**TOWN OF LOS GATOS
PLANNING COMMISSION AGENDA
SEPTEMBER 09, 2026
110 EAST MAIN STREET
TOWN COUNCIL CHAMBERS
7:00 PM**

SUBJECT: Consider an Appeal of a Community Development Director Decision to Approve a Request to Construct a Second-Story Addition to an Existing Single-Family Residence on Property Zoned R-1:8. **Located at 16717 Chirco Drive.** APN 424-20-014. Minor Residential Development Application MR-24-018. Categorically Exempt pursuant to the California Environmental Quality Act, Section 15301: Existing Facilities. Property Owner: Deepak Gupta. Applicant: My Troung. Appellant: Zahra Hajihashemi. Project Planner: Maria Chavarin.

Re: Objection to Proposed Two-Story Addition at 16717 Chirco Drive, Los Gatos, CA 95032 (APN 424-20-014) — Application No. MR-24-018 / Revised Plans dated 02/23/26 (Bay Area Project Pro)

SOLAR DIAGRAM

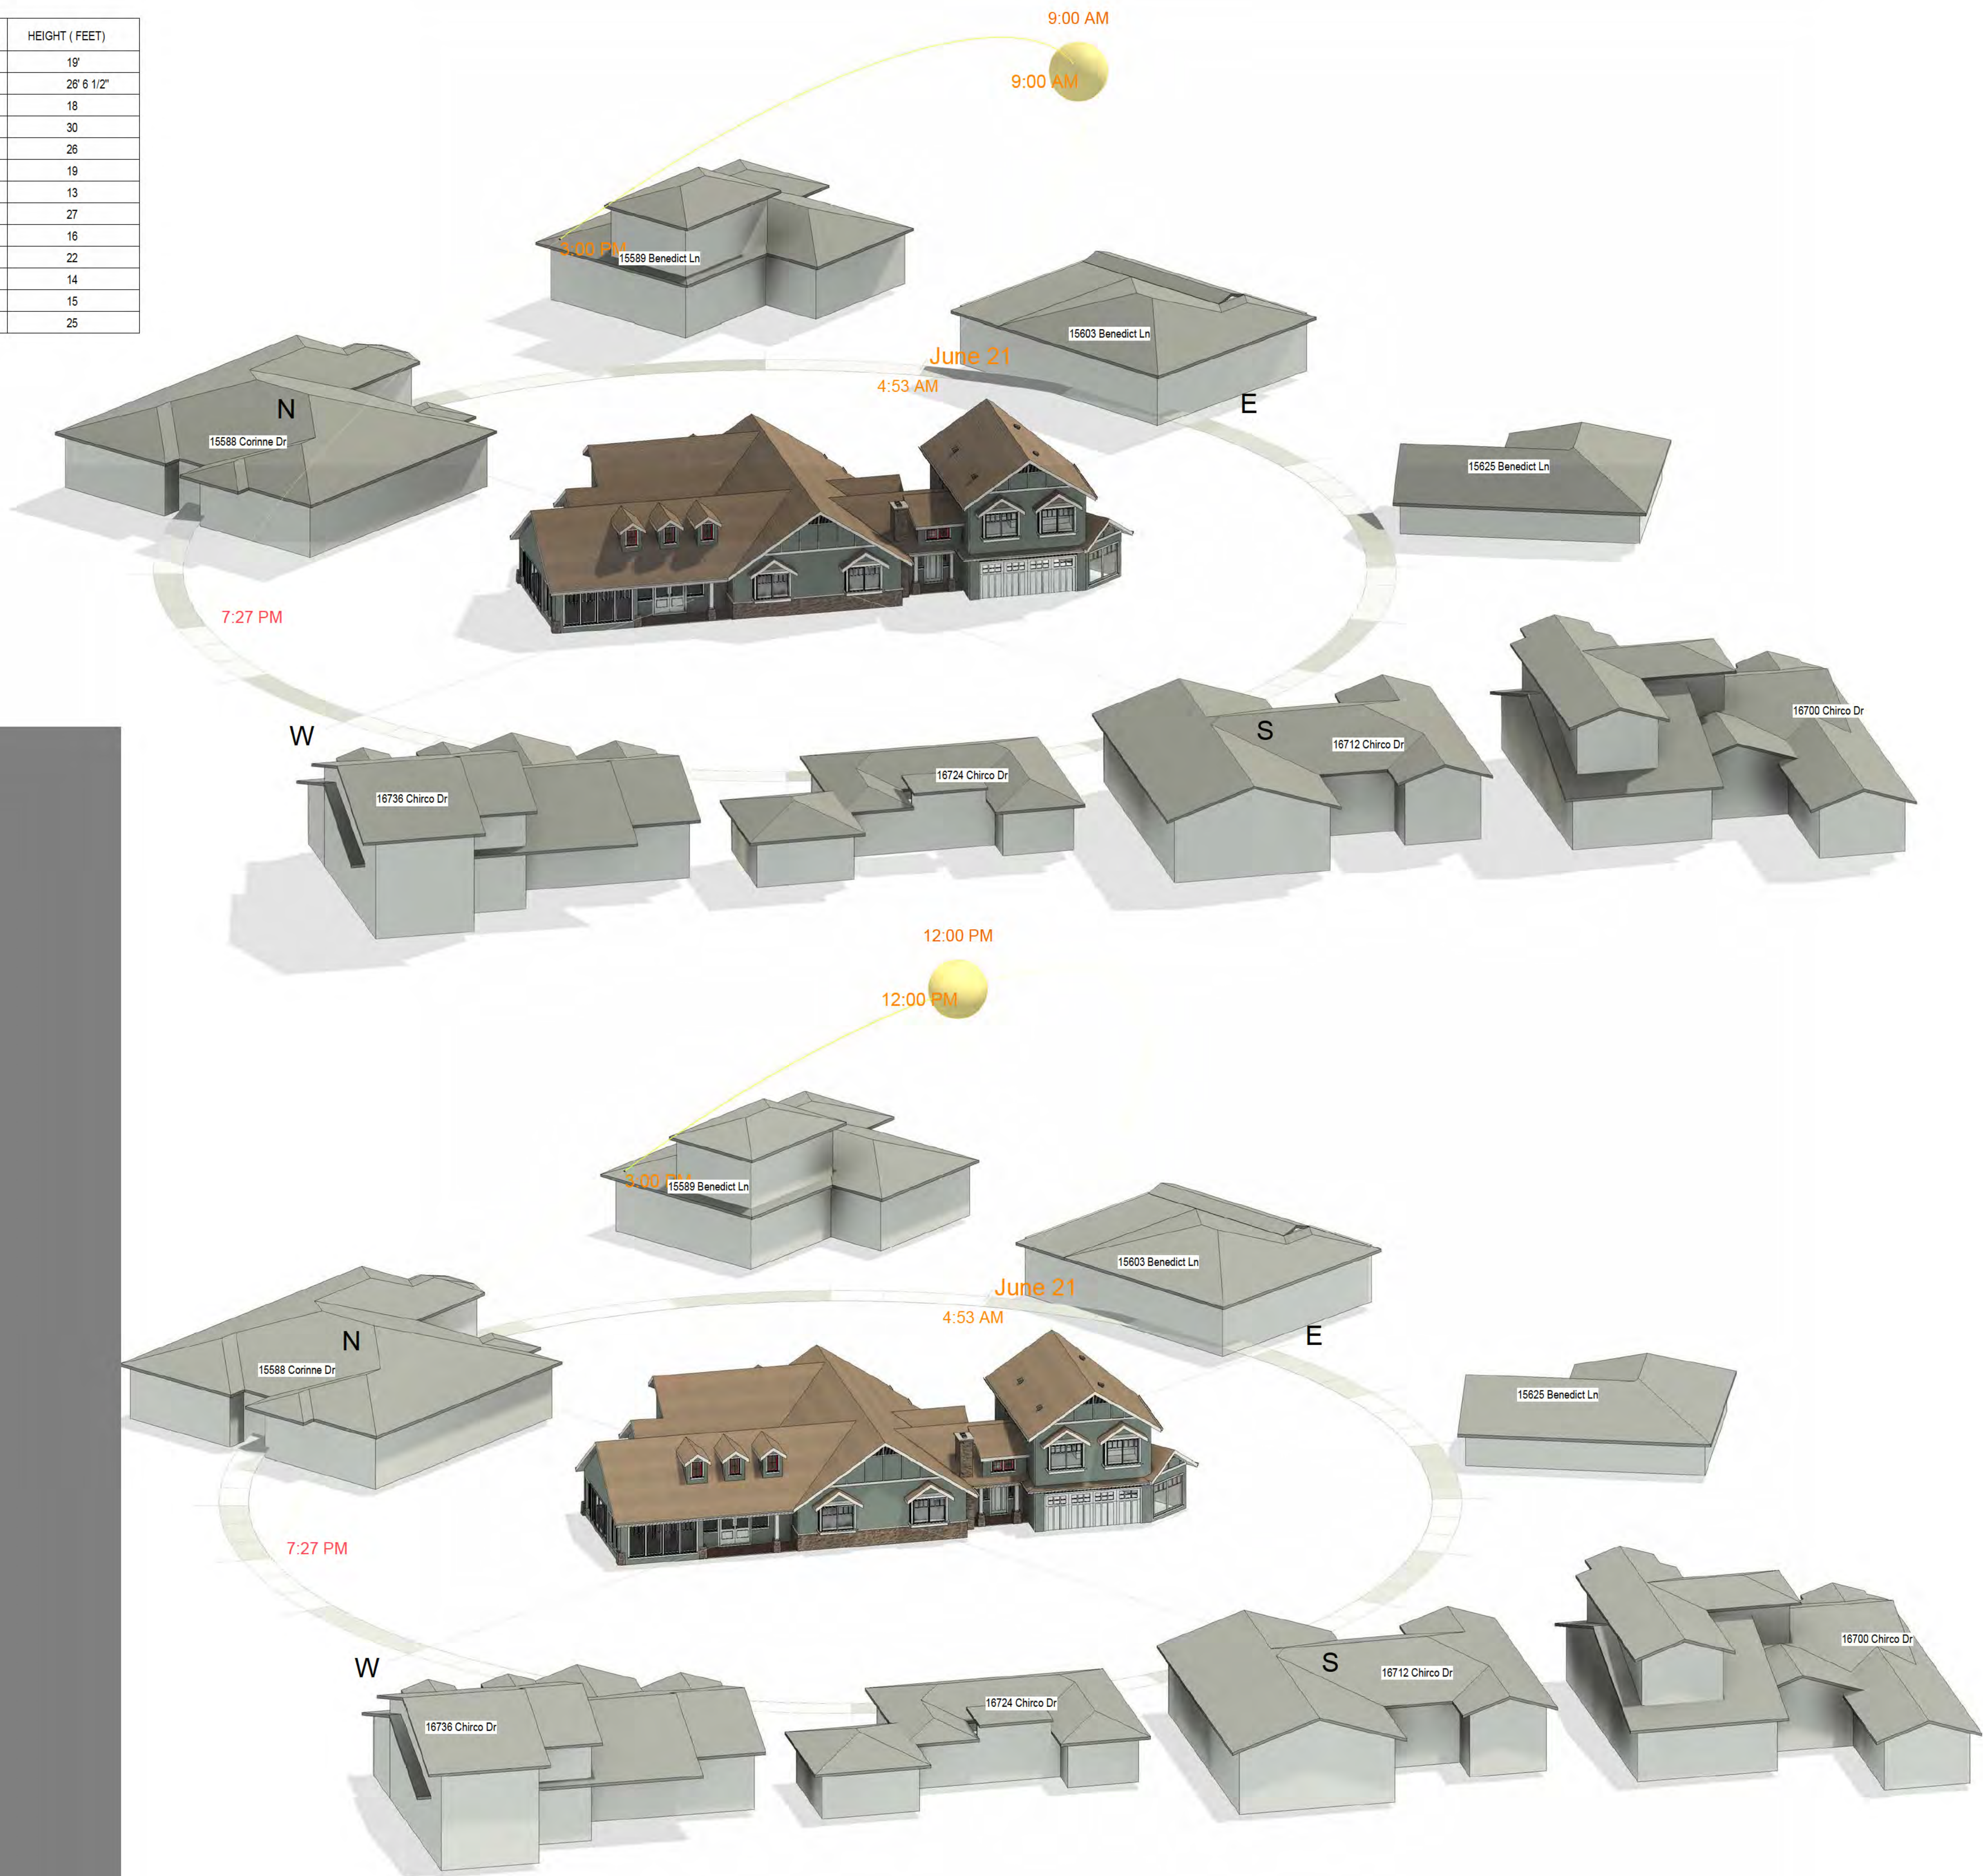
2. Shadowing, loss of sunlight, and an inadequate shadow study. The applicant submitted a shadow (solar) study on Sheets A.18–A.20, modeling December 21 and June 21 at several times of day. That study depicts only the building masses of the surrounding homes. It does not show my swimming pool, my mature trees, or my rear-yard landscaping, and therefore does not evaluate the project's actual shadow impact on the features of my property that depend on sunlight. I do not believe it accurately represents the impact on my yard. Because my home lies to the east of the new second story — and the applicant has placed the new second-story mass on the east side of the house, closest to my property — the added height would cast afternoon shadows, and especially long, low-angle winter-afternoon shadows, eastward across my rear yard, pool, and trees (a conceptual illustration of this afternoon shadow is attached as Exhibit A). This matters for two specific reasons: (a) I rely on direct sunlight to warm my swimming pool, and shading the pool would reduce the water temperature and the months it is usable; and (b) sunlight is necessary to sustain my rear-yard landscaping and the mature trees in my back yard, which would decline if they are overshadowed by the new second story. I ask the Town to require an independent, verifiable plan-view shadow study, including the winter solstice, that specifically locates and evaluates the impact on my pool and my trees and landscaping, and to require that the second-story massing be revised to reduce shadowing on my property.

2. **Shadowing, loss of sunlight, and an inadequate shadow study.** The applicant submitted a shadow (solar) study on Sheets A.18–A.20, modeling December 21 and June 21 at several times of day. That study depicts only the building masses of the surrounding homes. It does not show my swimming pool, my mature trees, or my rear-yard landscaping, and therefore does not evaluate the project's

actual shadow impact on the features of my property that depend on sunlight. I do not believe it accurately represents the impact on my yard. Because my home lies to the east of the new second story — and the applicant has placed the new second-story mass on the east side of the house, closest to my property — the added height would cast afternoon shadows, and especially long, low-angle winter-afternoon shadows, eastward across my rear yard, pool, and trees (a conceptual illustration of this afternoon shadow is attached as Exhibit A). This matters for two specific reasons: (a) I rely on direct sunlight to warm my swimming pool, and shading the pool would reduce the water temperature and the months it is usable; and (b) sunlight is necessary to sustain my rear-yard landscaping and the mature trees in my back yard, which would decline if they are overshadowed by the new second story. I ask the Town to require an independent, verifiable plan-view shadow study, including the winter solstice, that specifically locates and evaluates the impact on my pool and my trees and landscaping, and to require that the second-story massing be revised to reduce shadowing on my property.

Staff's Response: The Town Code does not prohibit or limit additions due to casting shadows on an adjacent residence in the case where there are no existing solar panels being affected. The appellant's residence does not currently include solar panels. The property owner responded to the appellant and provided an updated shadow study (Exhibit 10) that evaluates shadow impacts on the neighboring property throughout different times of the year.
